MAXINE HALL HEALTH CENTER RENOVATION AND SEISMIC UPGRADE

CIVIC DESIGN REVIEW - PHASE 3 : JUNE 25, 2018

MAXINE HALL HEALTH CENTER
RENOVATION AND SEISMIC UPGRADE
REVISIONS AFTER CDR 2 (11/27/2017) APPROVAL

Scale: 1/4" = 1'

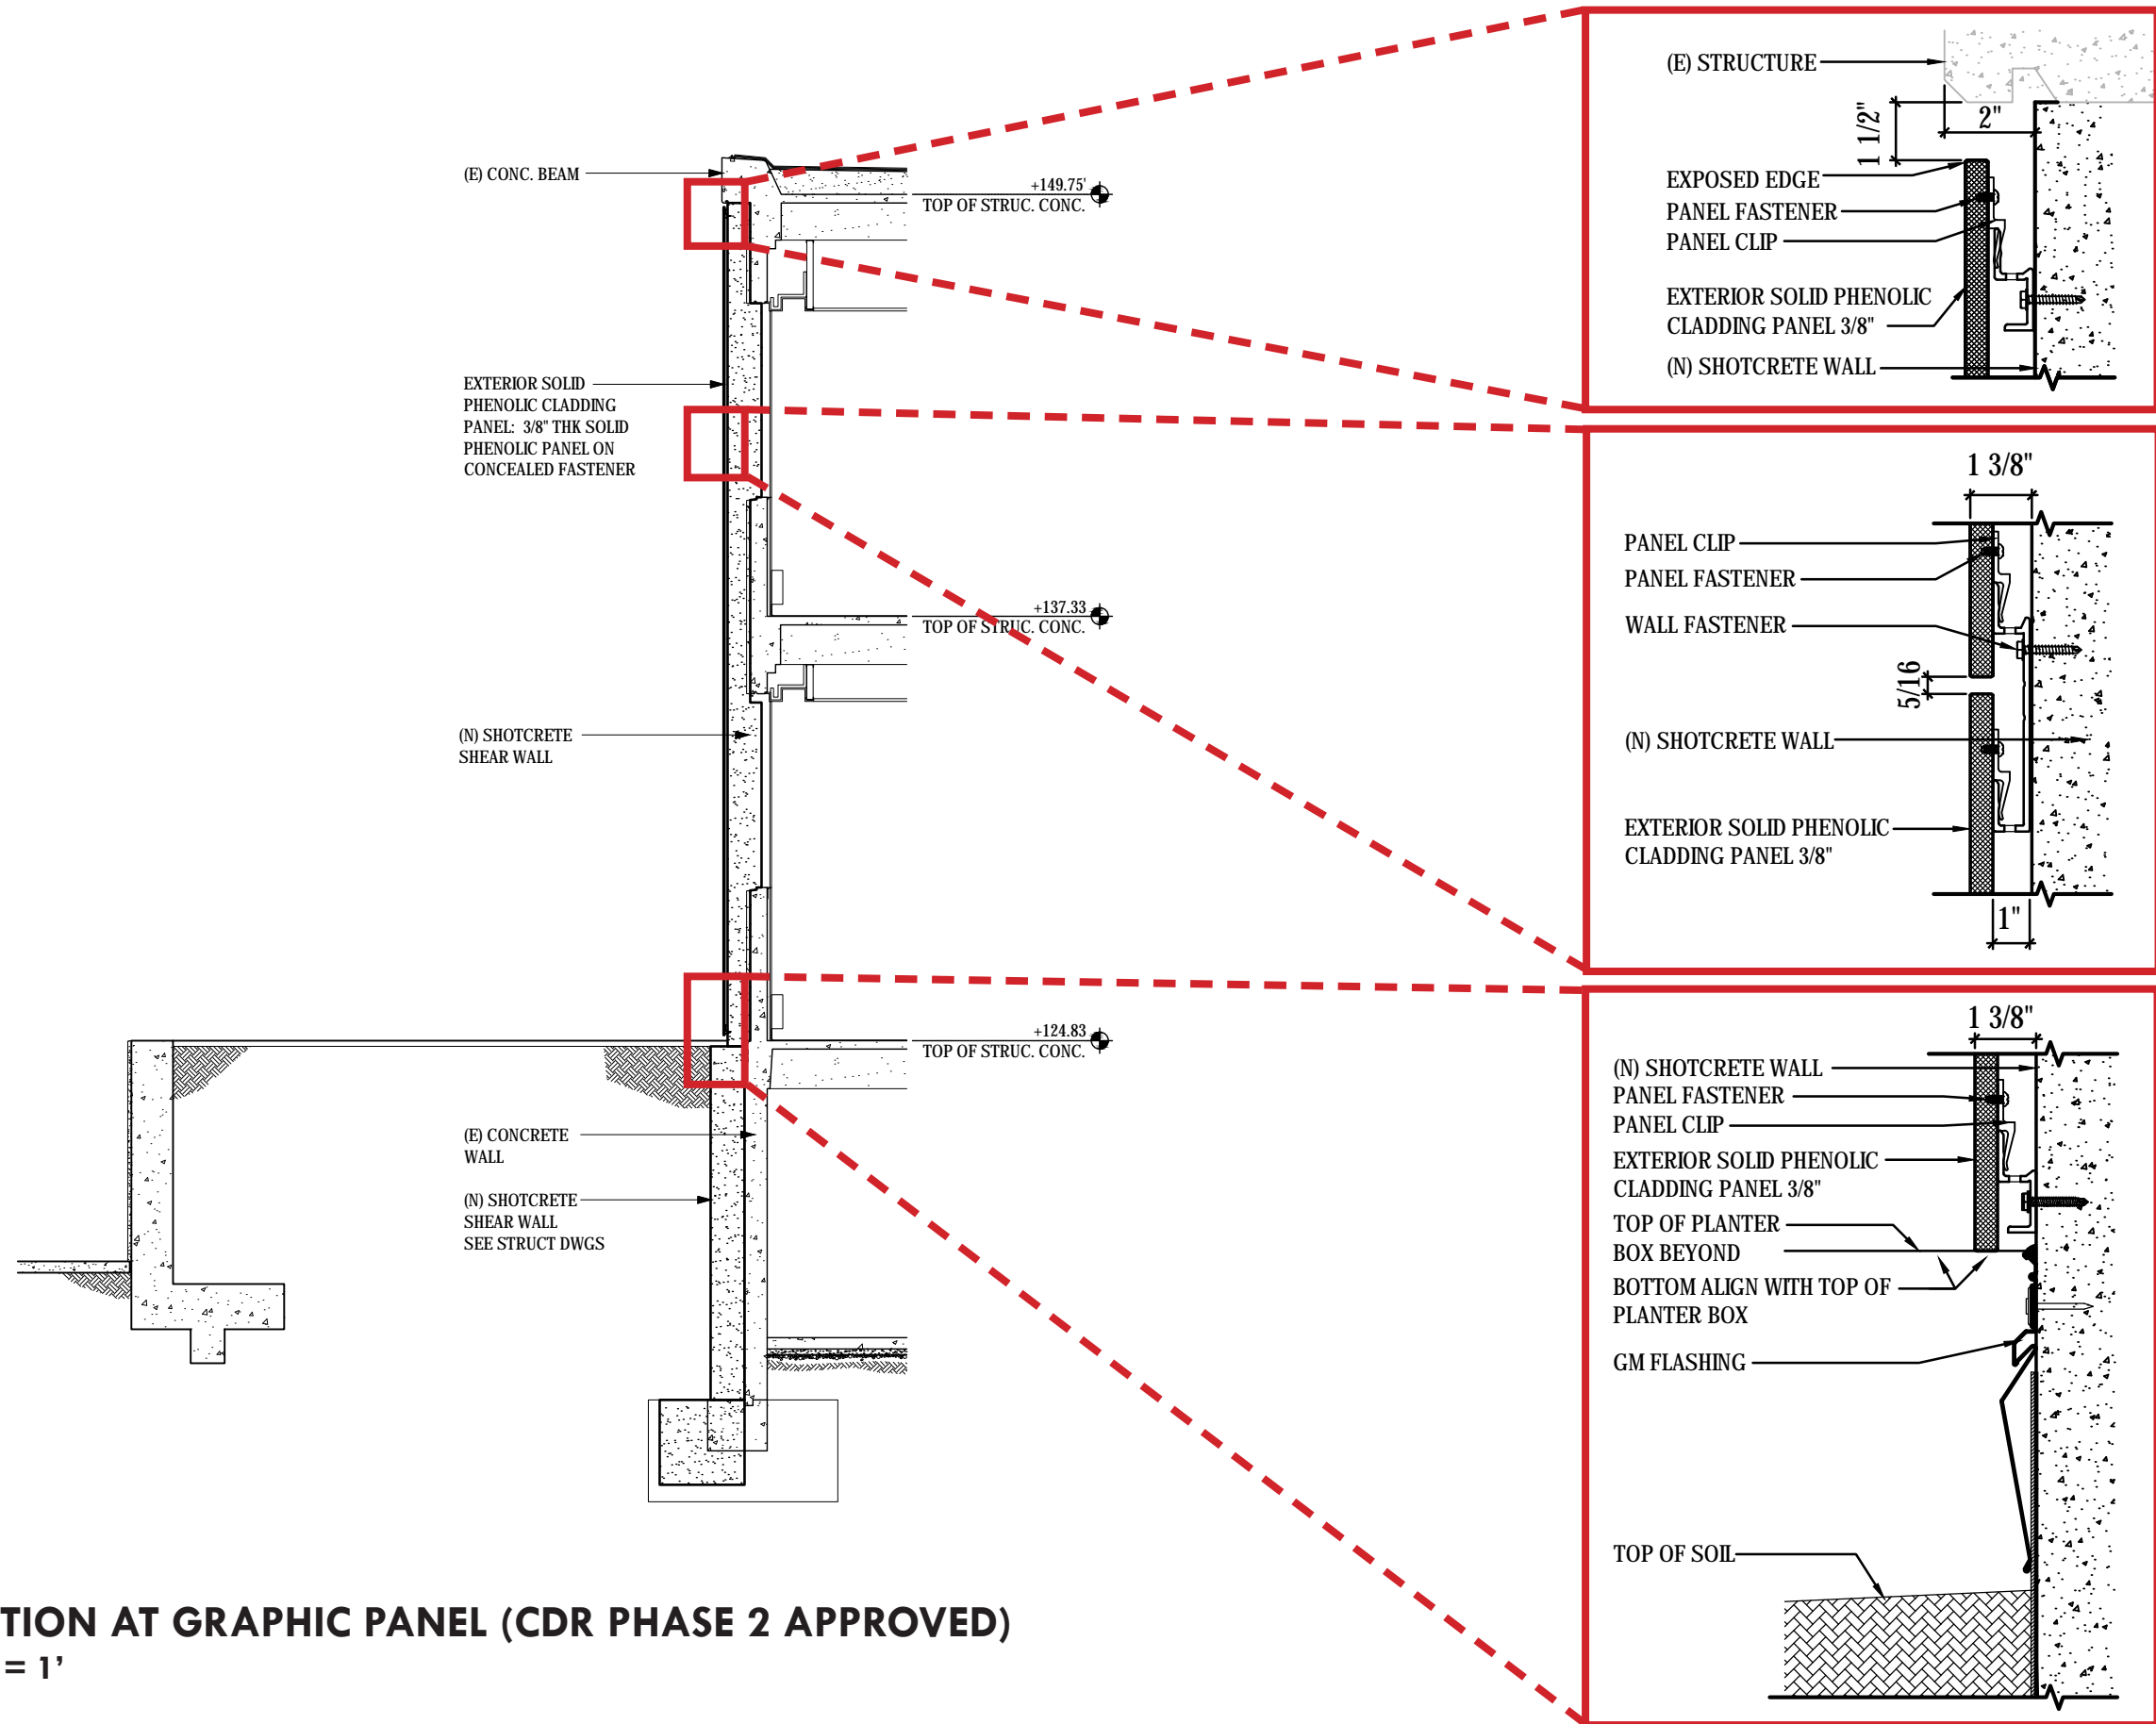
1. South Elevation Graphic Wall :

We are proposing a minor revision to the Graphic Wall; The concrete shear wall is now moved to the interior of the building, allowing the exterior plane of the graphic wall to be set back from the surrounding concrete frame in keeping with the existing historic facade. (Revision per Historic Preservation planning recommendation)

WALL SECTION AT GRAPHIC PANEL (NEWLY PROPOSED)

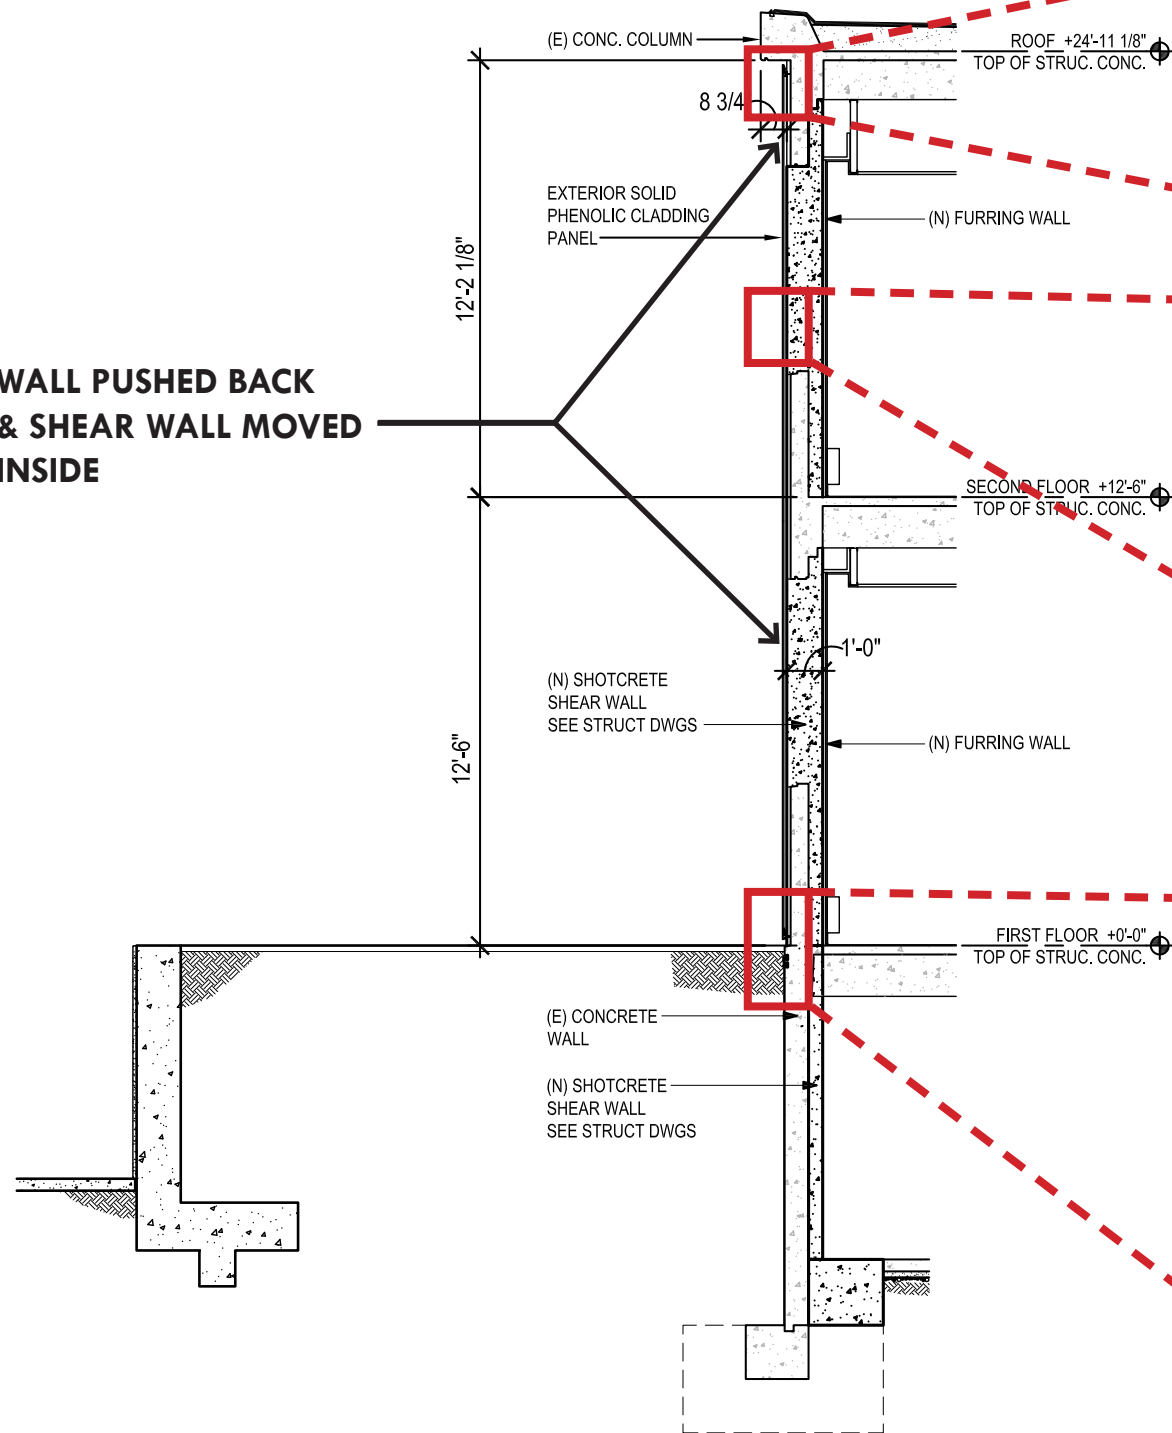
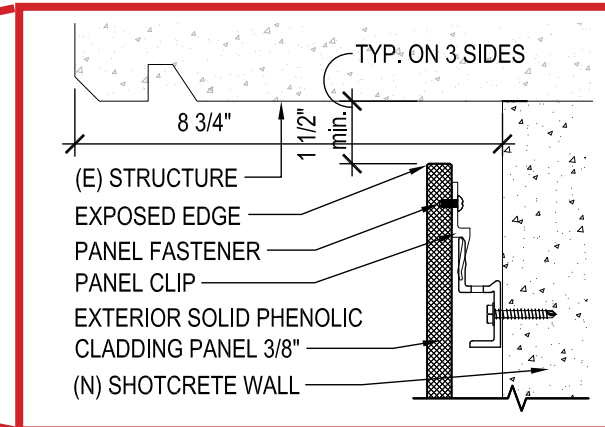
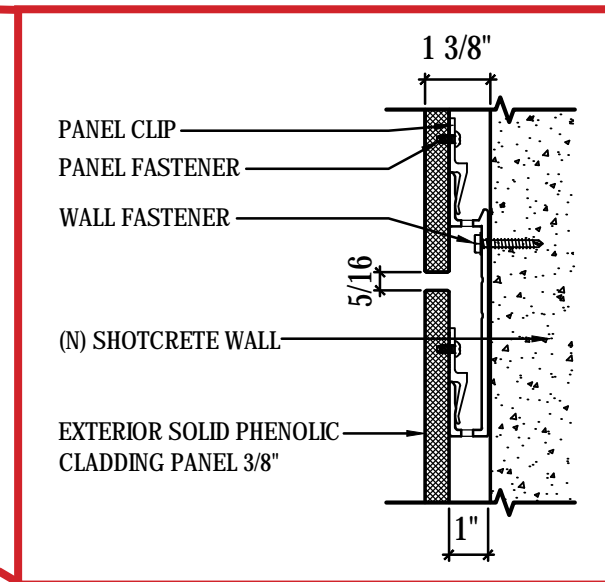
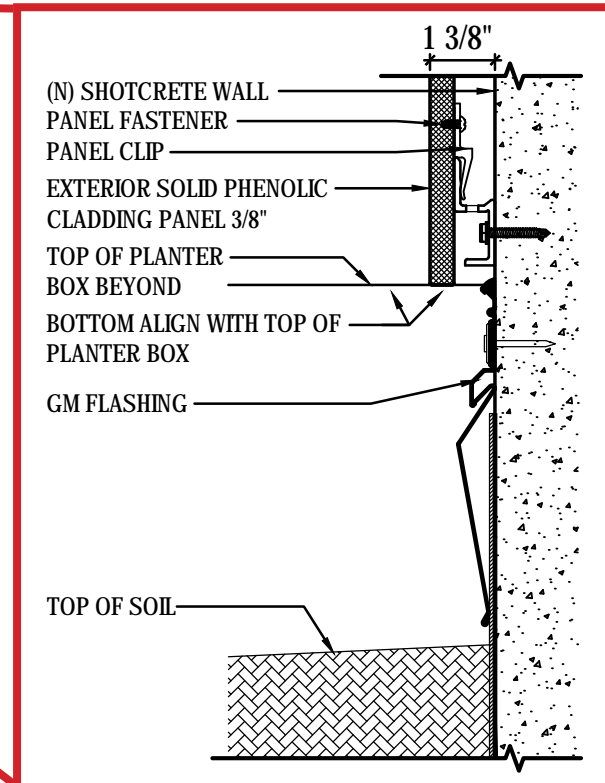
**WALL PUSHED BACK
& SHEAR WALL MOVED
INSIDE**

HANDRAIL/GUARD RAIL REVISION

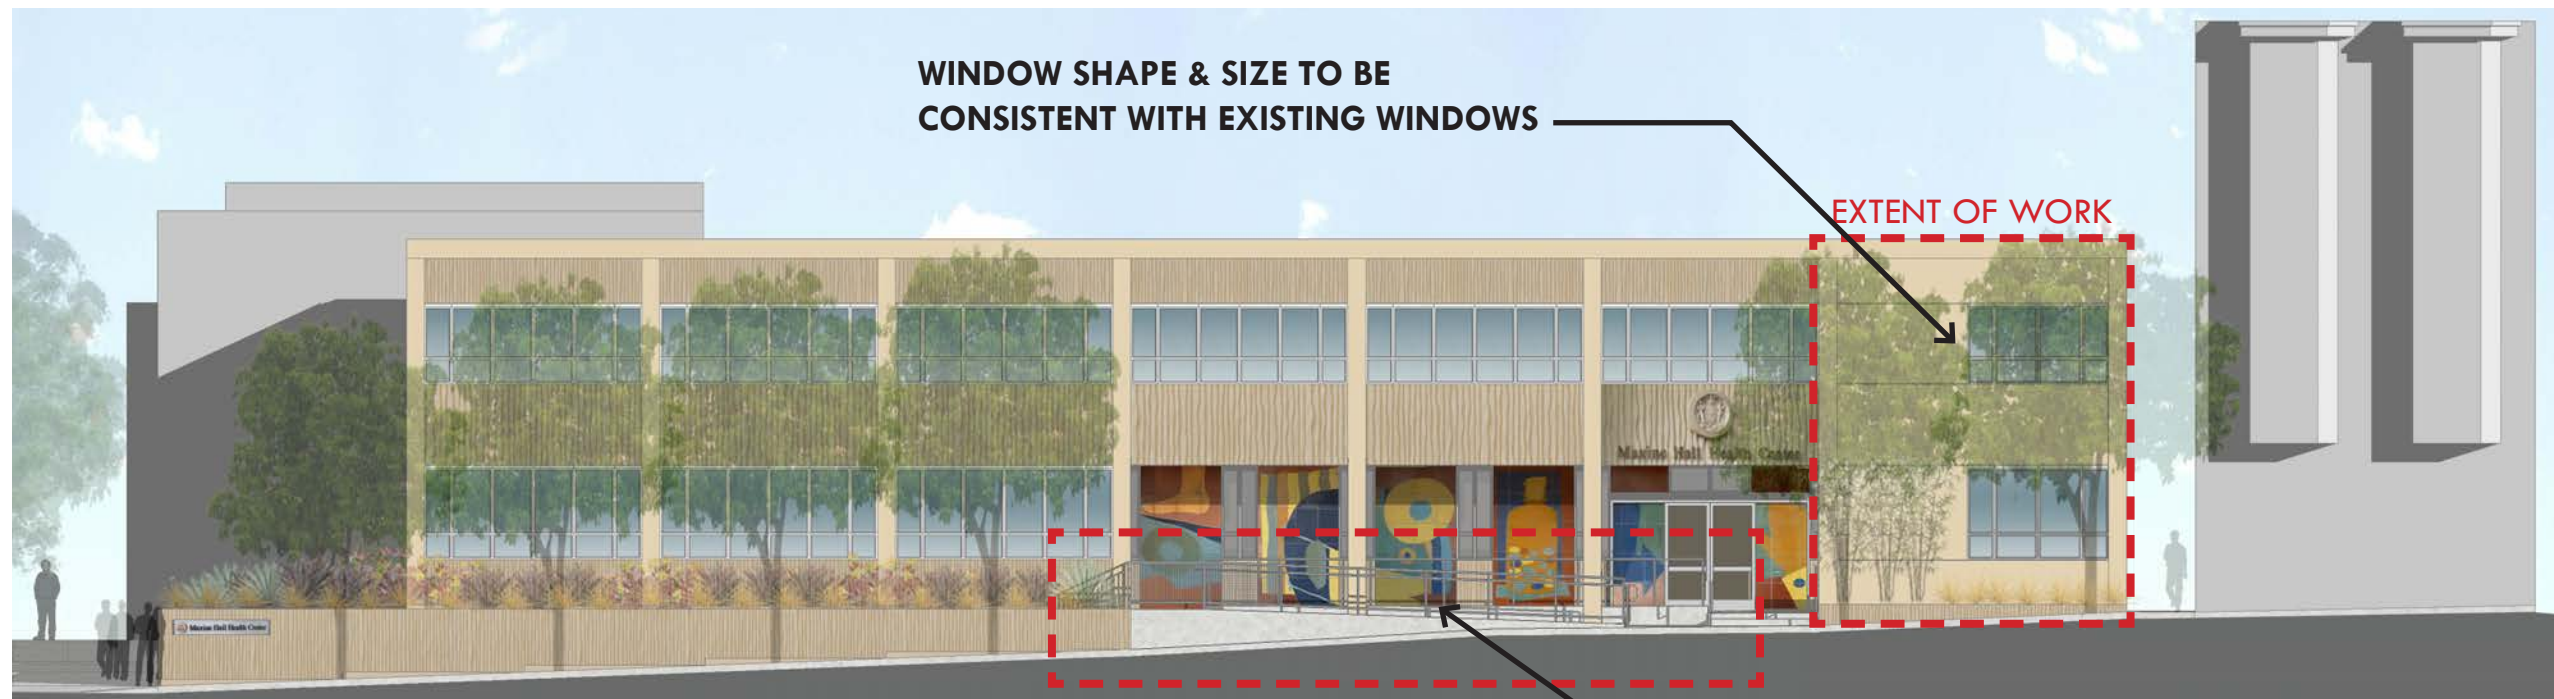
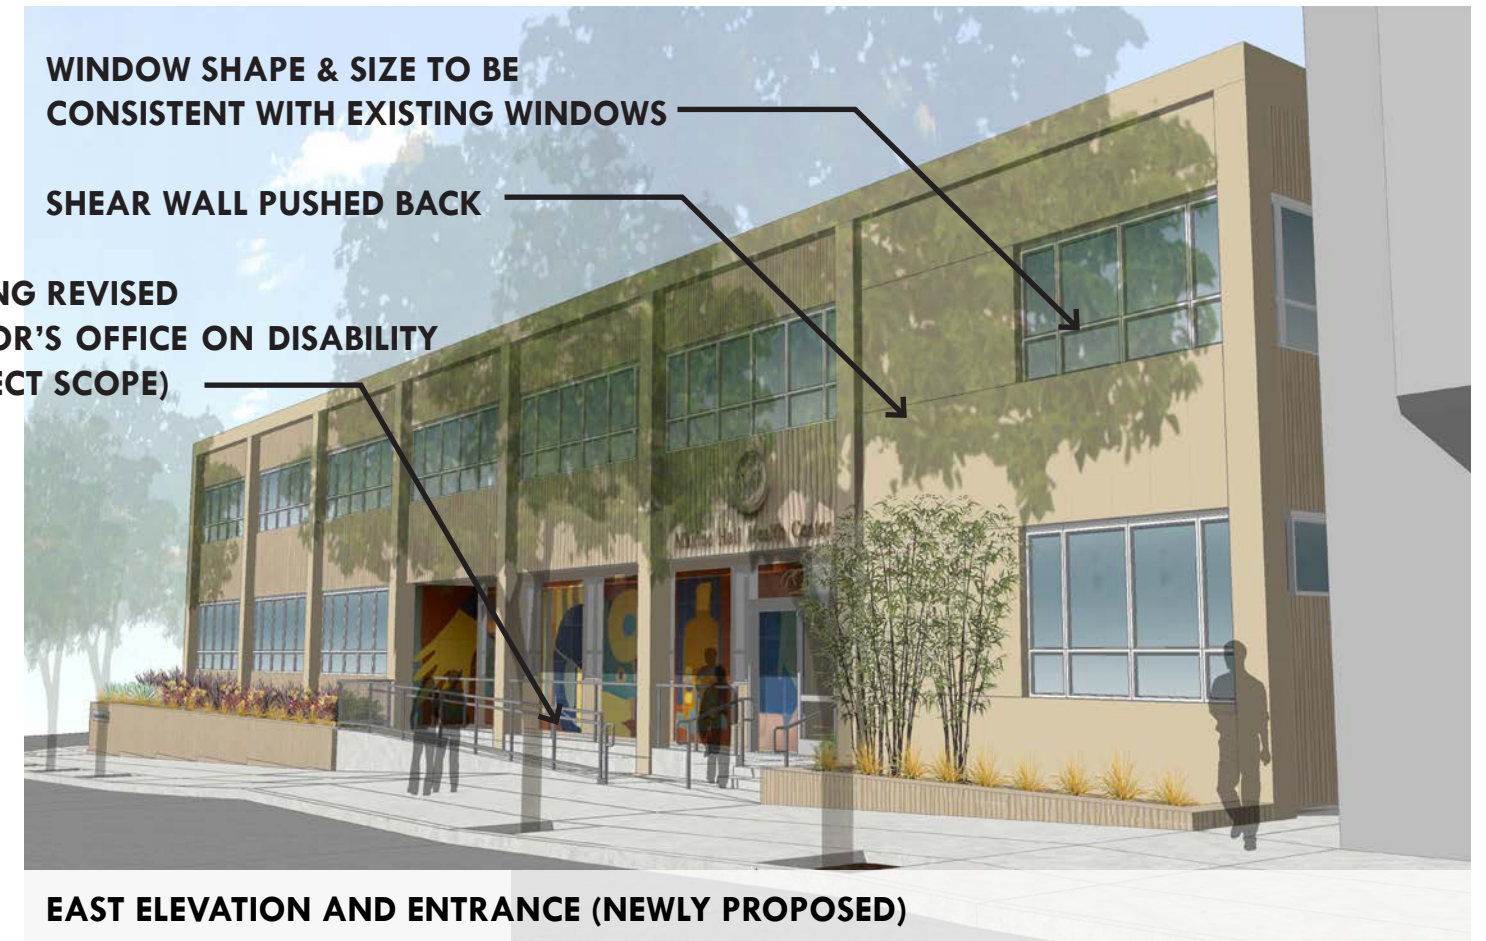
3. Handrail/Guardrail at East Front Entry:

We are proposing a redesigned handrail at the front entry ramp to allow for better visibility to the ceramic tile mural. (Revision per CDR Phase 2 comments)
